*TOLEDO CITY
PLAN COMMISSION
REPORT*

November 7, 2013

**TOLEDO-LUCAS COUNTY PLAN COMMISSIONS
APPLICATION DEADLINE, AGENDA, STAFF REPORT AND HEARING
SCHEDULE - 2013**

PROPOSED SITE PLAN

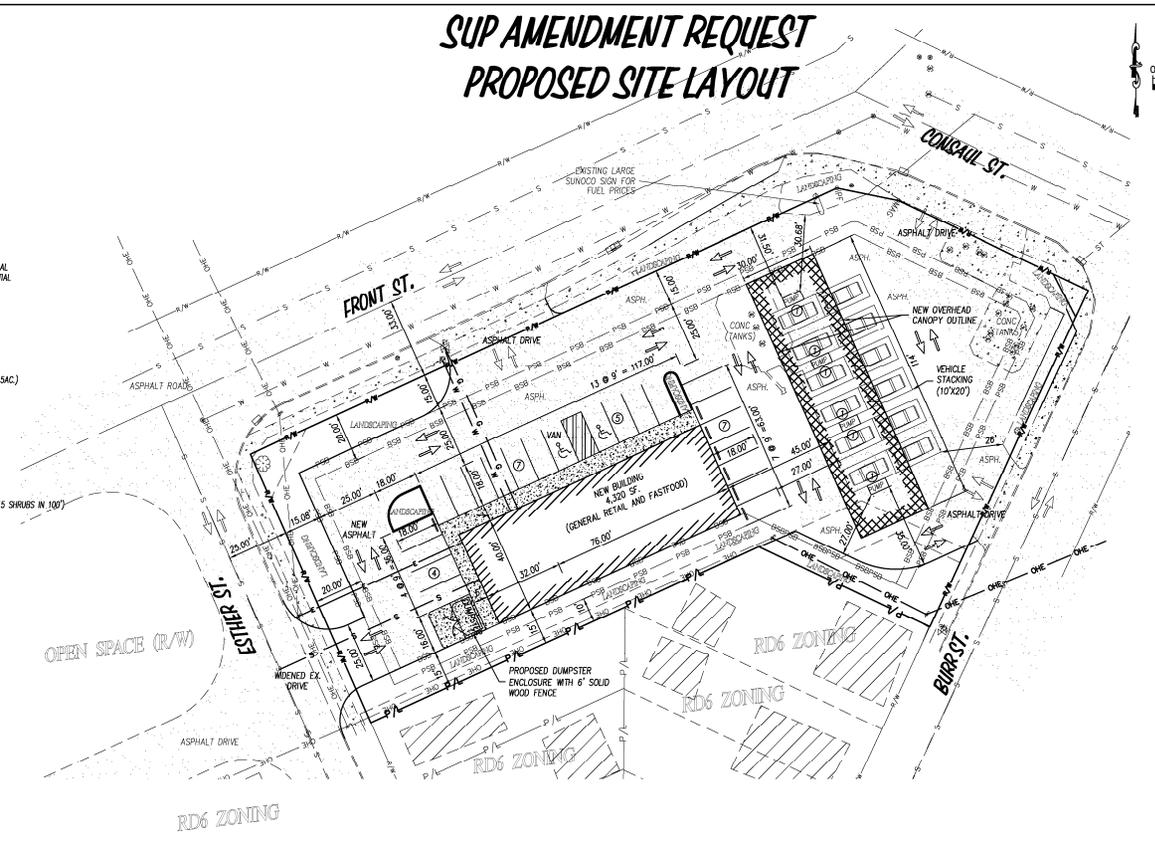
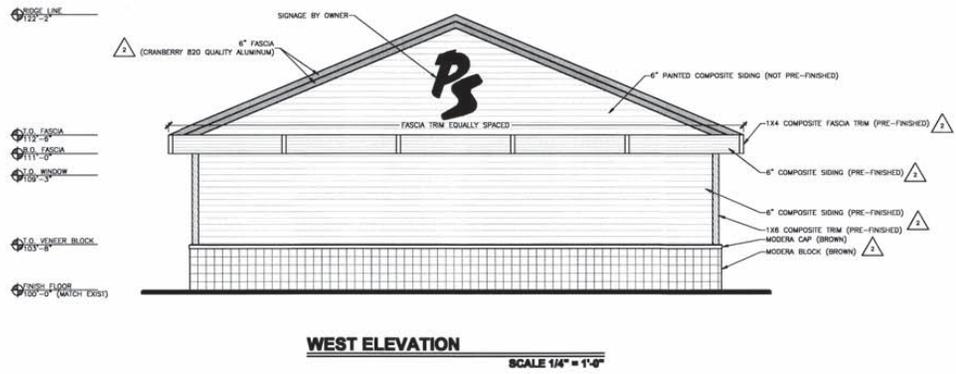
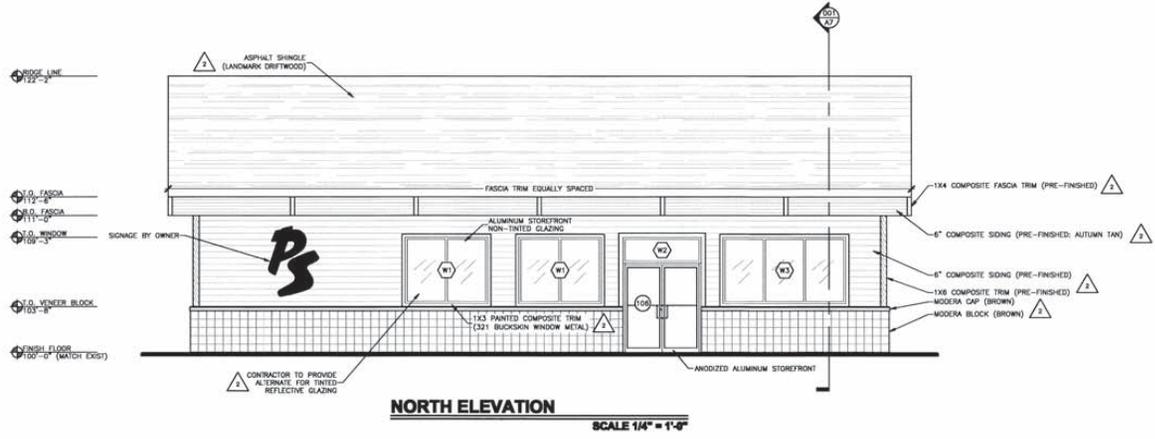
Pursuant to TMC§1107.0304 *Parking, Loading, and Access* – Schedule A, a convenience store with fuel sales is required to have one (1) parking space per pump (count as if parked at pump) plus one (1) parking space per 300 square feet of customer area. The total number of parking spaces that are required is 23. The site plan submitted depicts 24 parking spaces and is in compliance with the zoning code. The site plan indicates the new fuel pumps and canopy will be located on the east side of the convenience store and will be accessed from curb cuts on Front Street, Consaul Street, and Burr Street.

Pursuant to TMC§1108.0202 *Landscaping and Screening* – An extensively landscaped frontage greenbelt shall be provided along public right-of-ways, but not including alleys. Frontage greenbelts shall be a minimum width of 15 feet. This site is unique in that it has 3 frontages and therefore must provide 3 greenbelts. Additionally the south side of the property abuts a residentially zoned district and a Type A landscape buffer with a minimum width of 10 feet along with a solid fence shall be provided along this property line. Finally, interior parking lot landscaping will be required. A landscape plan shall be submitted indicating compliance with these requirements.

40. Ingress and egress to a parking lot in a Commercial or Industrial zoning district must be from a major street or from a street located in a Commercial or Industrial district with Commercial or Industrial zoning on the opposite side of the street (TMC§1107.1203). **Acceptable as depicted on site plan.**

ELEVATION

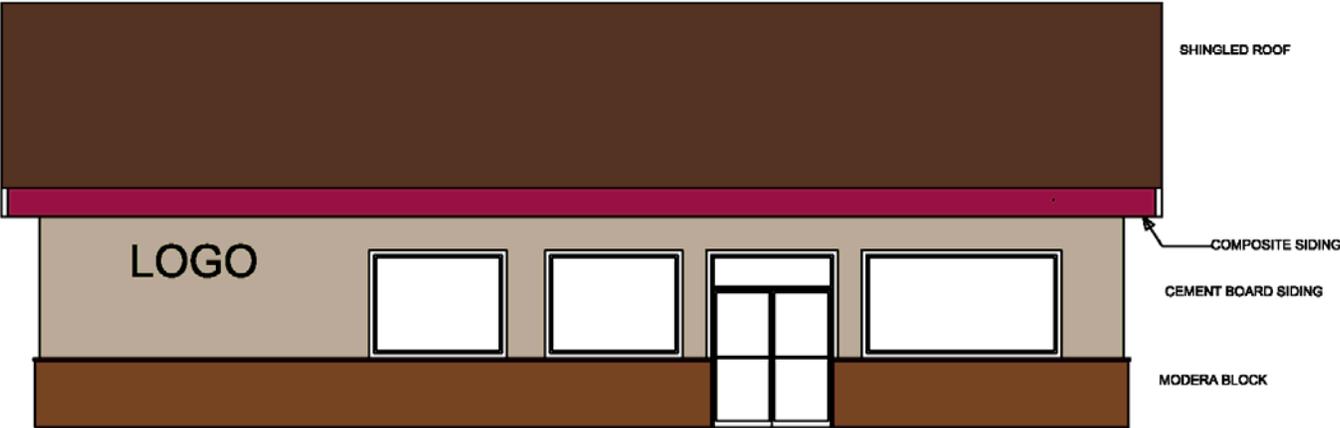
A building elevation has been submitted indicating cement board siding as the predominant exterior building material. The roof will be shingled and the building mass will be broken down via the use of a concrete block base. While these materials are acceptable, the elevation does not list colors of materials or indicate percentages of each proposed material. A revised elevation shall be submitted adding this detail. Staff further recommends that additional façade treatments or variation in massing, as detailed in TMC§1109.0205.A and C be incorporated into the building design. These changes shall be reflected in the revised building elevation.

41. The building design shall meet the requirements of TMC§1109.0200 *Commercial, Mixed Use and Institutional Design Standards*. The building materials of the addition shall meet the requirements of TMC§1109.0500 *Building Façade Materials and Color*. Additional façade treatments or variation in massing as detailed in TMC§1109.0205 A and C shall be incorporated into the building design. **A building elevation shall be submitted indicating compliance with these criteria and shall detail percentage of each exterior building material and color.**

SITE PLAN

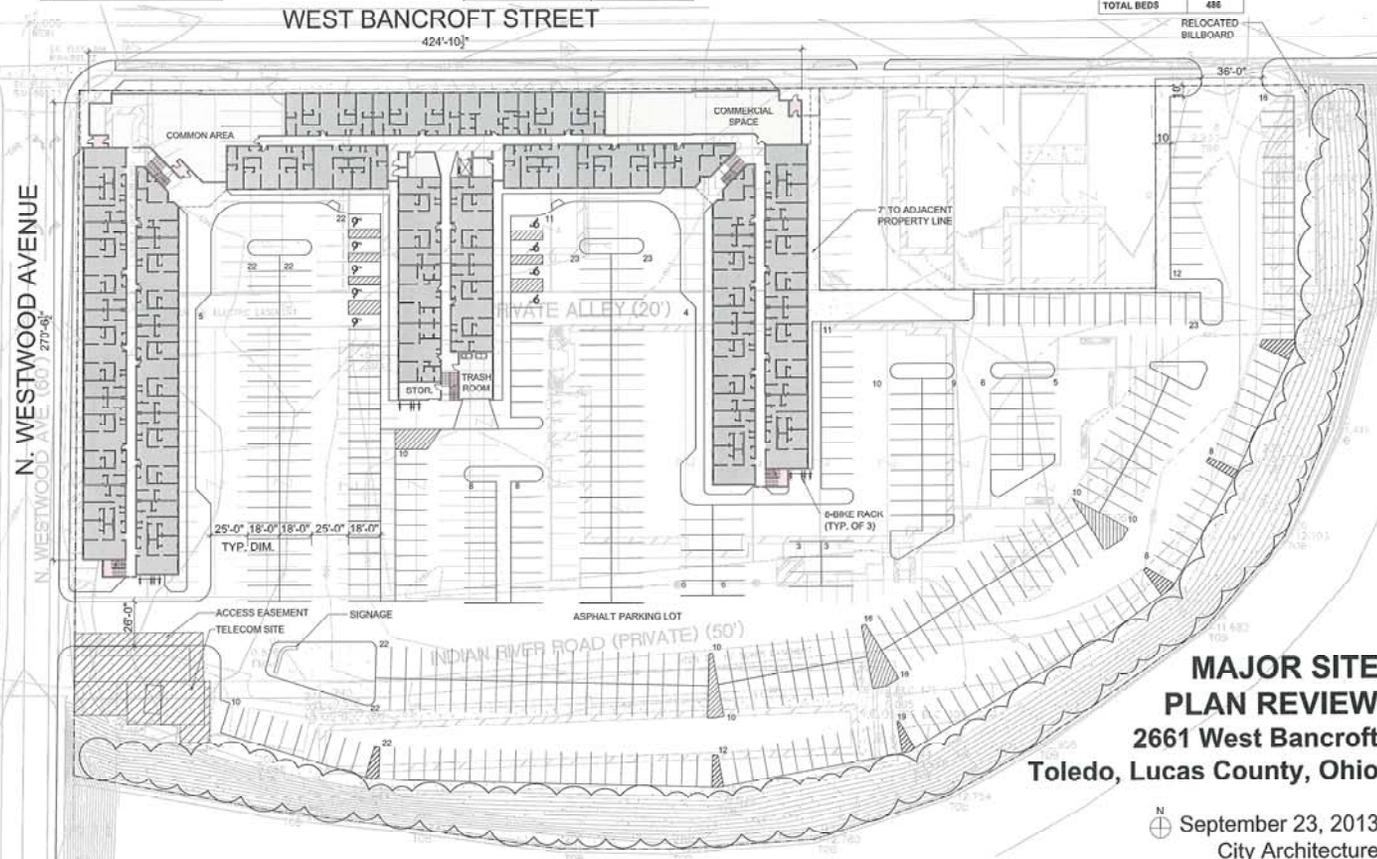
The site plan depicts a 445-space parking lot to be developed behind the building and accessed via one curb cut onto Bancroft Street and one curb cut onto Westwood Avenue. A multi-dwelling development is required to provide 1 ½ parking spaces per unit and one parking space for every ten units for visitor parking. The subject site is required a minimum of 230 parking spaces, along with twenty-three bicycle spaces. The proposed number of spaces exceeds 150% of the minimum number of required spaces. Therefore, an alternate parking plan will be required as a condition of approval documenting the need for the additional parking.

A landscape plan has been submitted depicting a greenbelt along Bancroft Street offering fifteen (15) street trees. The greenbelt is located within the Bancroft Street right-of-way. This is acceptable within the confines of the urban commercial landscape standards. However, as a condition of approval the applicant will be required to obtain approval of the Division of Engineering Services and the Division of Parks, Recreation, and Forestry.

A greenbelt is offered along Westwood Avenue, a portion of which is located within the right-of-way. Staff recommends that street trees or shrubs be added in this right-of-way, also subject to review and approval of the Division of Engineering Services and the Division of Parks, Recreation, and Forestry. Interior site landscaping is offered via several parking lot landscape islands. Additional landscape islands in areas currently shown as paved but striped for no parking, will be required as a condition of approval.

28. A minimum drive aisle width of 25' is required to accommodate two-way traffic. Various drive aisles depicted on the site plan do not meet this minimum width.
29. Existing unused drive approaches shall be completely removed and new curbs and sidewalks shall be installed accordance with City of Toledo Construction Standards.
30. Crumbling and deteriorating curbs and sidewalks should be rebuilt in accordance with City of Toledo Construction Standards.

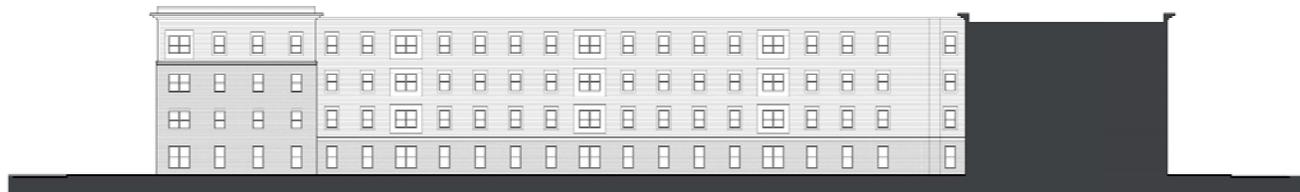
A building elevation has been submitted that complies with TMC§1109.0501 – *Façade Materials*. The north façade, along Bancroft Street, consists of eighty (80) percent high-quality materials (brick, hardiplank, and glass). The west façade, along Westwood Avenue, consists of seventy-nine (79) percent high-quality materials (brick, hardiplank, and glass). Vinyl and metal are used for banding and articulation purposes.

The east and south facades, oriented towards the parking lot, consist of forty-seven (47) percent high-quality materials. The predominant building material on these facades consist of vinyl siding. This is acceptable for the south façade which faces inward towards the Ottawa River and the parking lot. However, the east façade is visible from Bancroft Street and staff recommends that the percentage of vinyl siding be reduced so that seventy-five (75) percent of this façade consist of high-quality materials to comply with TMC§1109.0501. A revised elevation drawing has been submitted for the east façade with eighty-two (82) percent of the façade consisting of high-quality materials.

Additionally, staff recommends that the applicant submit a revised elevation providing more detail on depth of proposed building recesses to determine if the building mass is sufficiently broken up along Bancroft Street and Westwood Avenue façades.

37. The building materials shall meet the requirements of TMC§1109.0500 *Building Façade Materials and Color*. Elevations shall be submitted to meet the approval of the Plan Director. Exterior building materials shall not include concrete blocks, concrete panels or wood sheet goods. The façade colors shall be low-reflectance, subtle, neutral or earth tone colors. **The submitted elevations shall be revised to include additional detail on the depth of proposed building's recesses. Proposed awning shall be extended along the Bancroft Street frontage.**
